Responses to comments from anonymous Reviewer #1

On “Assessing the different components of the water balance of Lake Titicaca” by Nilo Lima-Quispe Denis Ruelland, Antoine Rabatel, Waldo Lavado-Casimiro, and Thomas Condom.

Responses to comments from Dr. Benjamin Kraemer

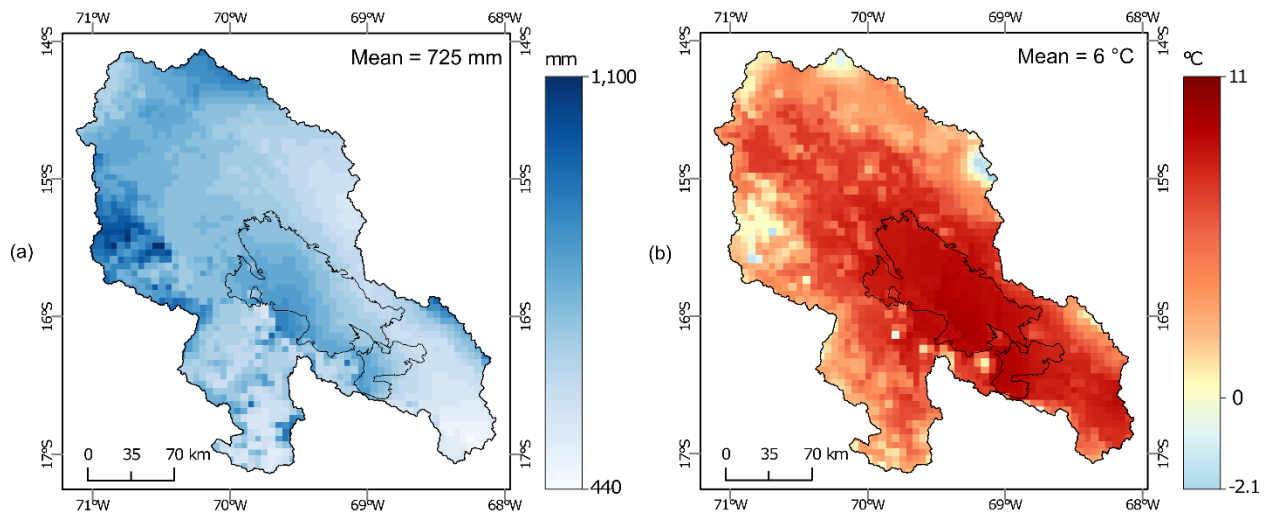
Figure 2, panel b: Adjust the color bar to ensure white corresponds to zero or use a sequential color bar.

Agreed. To address the reviewer's comment, the figure has been modified using diverging colors, with yellow corresponding to zero Celsius degree. Here is the revised figure:

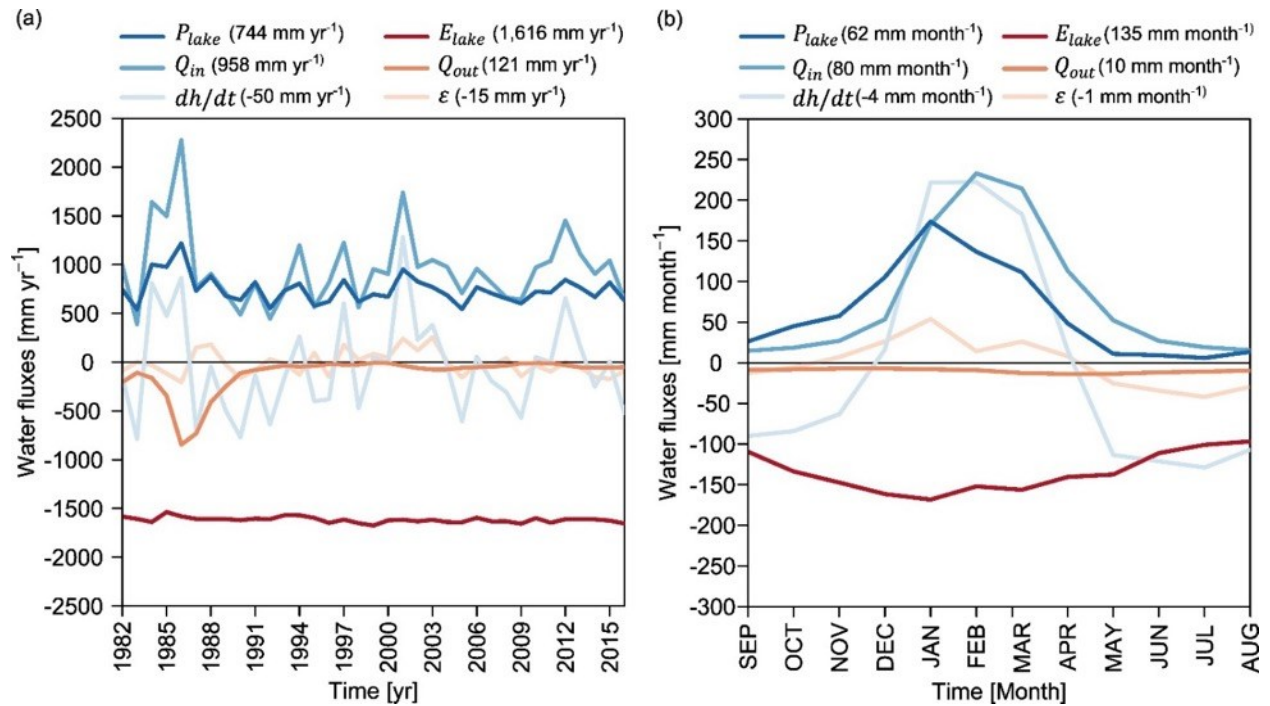
Fig. 12: add the “mm/year and mm/month” to the numbers in the legend, or alternatively, put the numbers in a separate table would allow to compare them more clearly.

Agreed. We believe that both suggestions help to clarify and better highlight our results. We have added the units to the figure and included a table with the values of the water balance components.

Figure B1. Lake surface water temperature (LSWT) simulated with the Air2waterR model (Piccolroaz et al., 2013; Toffolon et al., 2014) for Lake Titicaca and its calibration and evaluation performances.

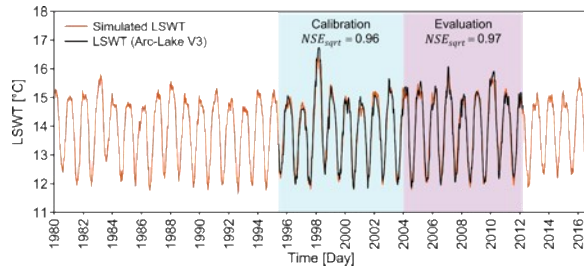
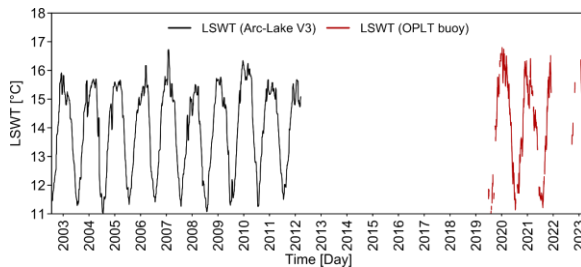
- **Lines 445-446:** Consider using Lake Surface Water Temperature (LSWT) data available from remote sensing sources, such as the ESA Lakes Climate Change Initiative, which might provide more accurate results in a hydrosystem driven by net radiation and evaporation.

In this study we did not directly use remotely sensed LSWT data because our analysis period (1982–2016) extends beyond the coverage of available datasets. For example, ARC-Lake V3 covers 1995 to 2012, and the ESA Lake CCI spans 1995 to 2023. To obtain a daily time series for the entire period, we simulated the LSWT using the Air2Water conceptual model (with air temperature as input). We then calibrated and evaluated the model against ARC-Lake V3 data, achieving acceptable results, as shown in the following figure.

To assess the reliability of ARC-Lake V3, we compared it with on-site measurements from the OLT (<https://olt.geovisorumsa.com/>). As shown in the following figure, both datasets exhibit fluctuations within the same range.

To address this comment, we have added the following to the Methods section: “Since there are no long-term measurements of lake surface water temperature (LSWT) and the remotely sensed data sets do not cover the entire study period, the Air2Water model (Piccolroaz et al., 2013; Toffolon et al., 2014) was used to simulate LSWT. Calibration and evaluation were performed against ARC-Lake V3 remotely sensed data (MacCallum and Merchant, 2012) (see Appendix B).”

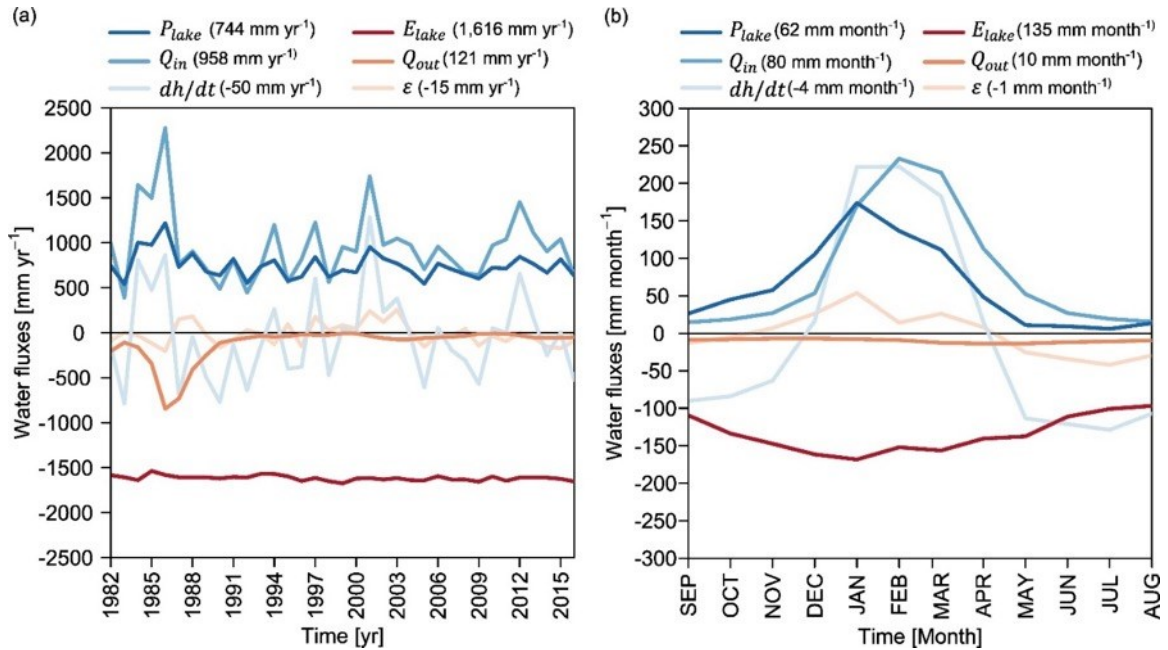
- **Lines 469-474:** Discuss the implications of excluding groundwater exchanges, especially in light of observed discrepancies in the water balance. Including a brief sensitivity analysis or discussion on the potential significance of this exclusion under different hydrological conditions could add depth to the analysis.

Agreed. We acknowledge that we did not discuss the implications of neglecting net groundwater flow in the originally submitted version. According to our results, the long-term water balance has

a minimal closure error (-15 mm yr^{-1}). A possible hypothesis is that this error corresponds to the net groundwater flow, although it is important to note that it also includes the uncertainty associated with the other components of the water balance. The error term indicates a seasonal variation with a positive pattern during the rainy season and a negative pattern during the dry season, suggesting that the lake-groundwater interaction varies seasonally (see following Figure, Figure 11b of the manuscript).

“Figure 11b shows that the error term exhibits a seasonal variation, being positive during the rainy season and predominantly negative during the dry season. Linking the error term to net groundwater flow suggests that groundwater-lake interactions are seasonally variable. Lake water levels fluctuate by an average of 67 cm over the hydrological year, reaching a maximum in April and a minimum in December. In Figure 11b, the error term has the highest positive values between December (26 mm) and January (54 mm), indicating a gain in net groundwater flow to the lake. When the lake reaches high water levels, losses to groundwater tend to dominate. This dynamic suggests that there could be a reversal of the hydraulic gradient throughout the year depending on the water level of the lake and the groundwater. However, it is important to note that the error term reflects not only the net groundwater flow, but also the uncertainty in estimating the other components of the water balance.”

Figure 2. Spatial distribution of (a) annual precipitation and (b) mean temperature for the hydrological period 1980–2016 according to GMET (Gridded Meteorological Ensemble Tool).

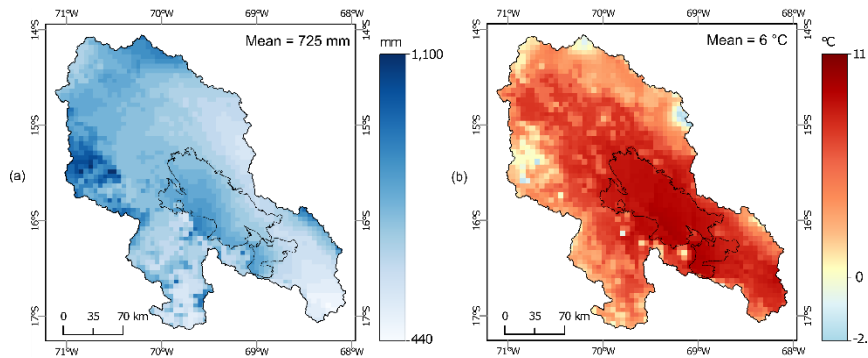
- **Figure 2, Figure 8:** Reverse the order of gradient legends so that low values are on the bottom and high values on the top.

- **Figure 2, Right Panel:** Adjust the color bar to ensure that white corresponds to zero, or use a sequential color bar to improve the visual interpretation of the data.

Agreed. The order of the legend values was reversed. Here are the modified figures:

Agreed. To address the reviewer's comment, the figure has been modified using diverging colors, with yellow corresponding to zero Celsius. See the modifications above.

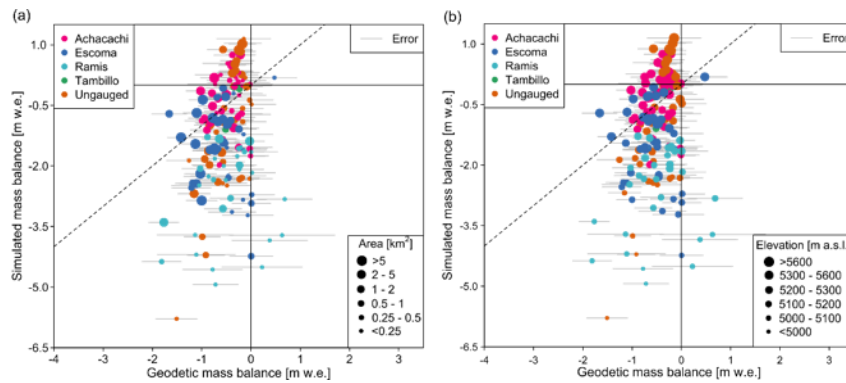
Figure 8: Highlight in the text that variability between glaciers for simulated mass balance is greater than for geodetic mass balance. What would be a possible explanation?

Agreed. We have highlighted the following in the text:

“...*The notable variability in model performance (Fig. 7b) could be attributed to inaccuracies in precipitation data for some catchments, as estimating precipitation in high-elevation remote areas remains a complex challenge (Ruelland, 2020)*”.
